Product Advisory (PA)

Subject: Introduce New T-type End Plug for n-SOIC rail (packing tube)

Publication Date: 6/8/2016

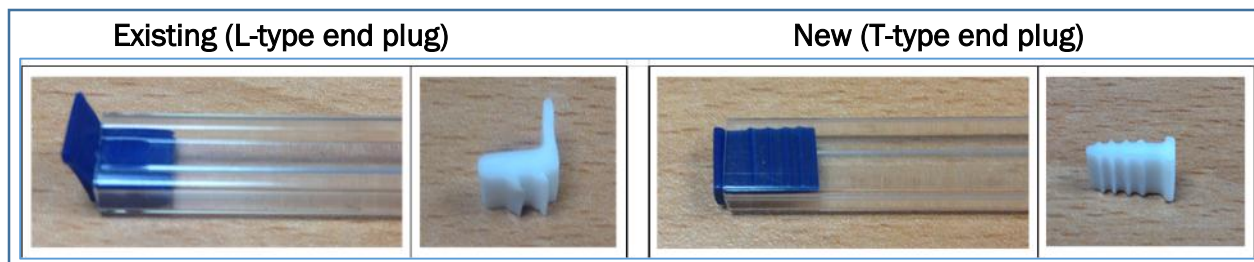
The L-type (existing) and T-type (new) end plug could be identified visually. The removal tab on the end plug appears as “T” shape for better locking to the rail (packing tube), which will

reduce loose end plug issue. There is no change to the color, material and critical dimension of the end plug and rail (packing tube).
